RB211 TRENT 700 SERIES PROPULSION SYSTEMS NON-MODIFICATION SERVICE BULLETIN

This document transmits Revision 2 to Service Bulletin RB211-73-AH522

TRENT 700 - LP FUEL TUBES, CLIPS, AND FOHE MOUNTING HARDWARE - INSPECTION FOR  
FRETTAGE - NON-MODIFICATION SERVICE BULLETIN - MOD.73-AH522

R Revision 2 of this NMSB is issued to revise Aircraft Maintenance Manual  
R reference in 3. Accomplishment Instructions and to revise Fig.9 to show correct  
R link orientation.

Arrangement of FOHE Lower Mounting Brackets, Struts and Links  
Fig.9

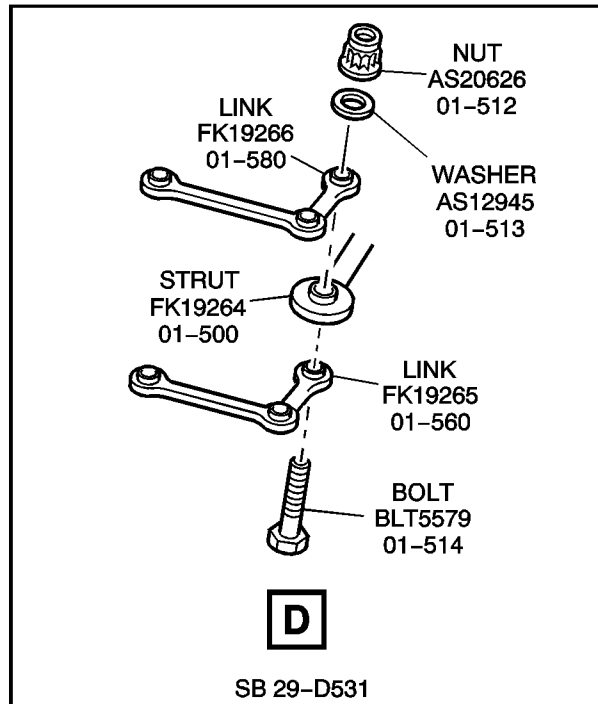
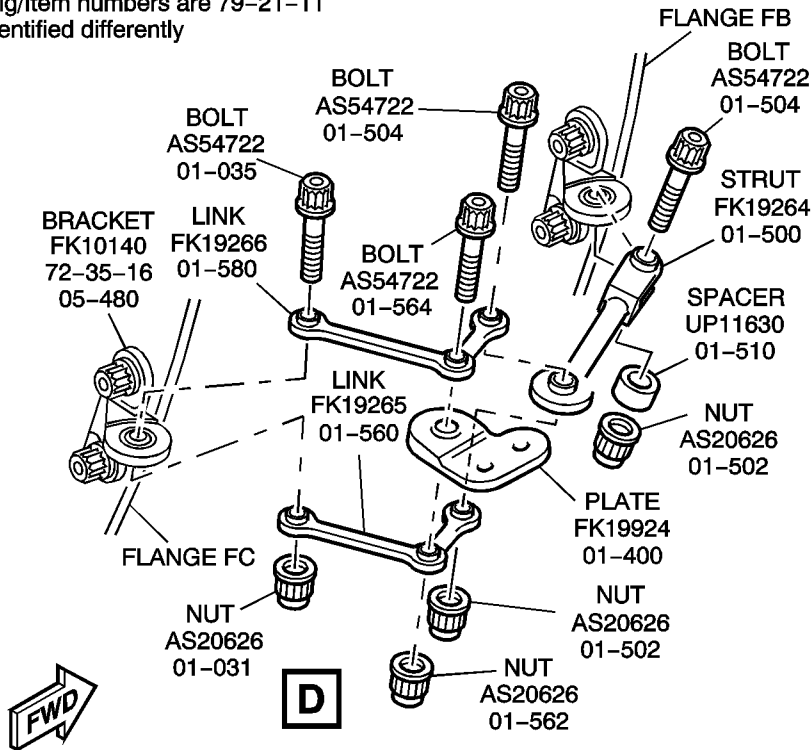
Remove	Incorporate	Reason for change
All pages of the Service Bulletin	Pages 1 to 36 of the Service Bulletin	To revise Aircraft Maintenance Manual reference in 3. Accomplishment Instructions and to revise Fig.9 (RR-RMR13446)
All pages of Appendix 1	Page 1 of Appendix 1	To revise Aircraft Maintenance Manual reference in 3. Accomplishment Instructions and to revise Fig.9 (RR-RMR13446)
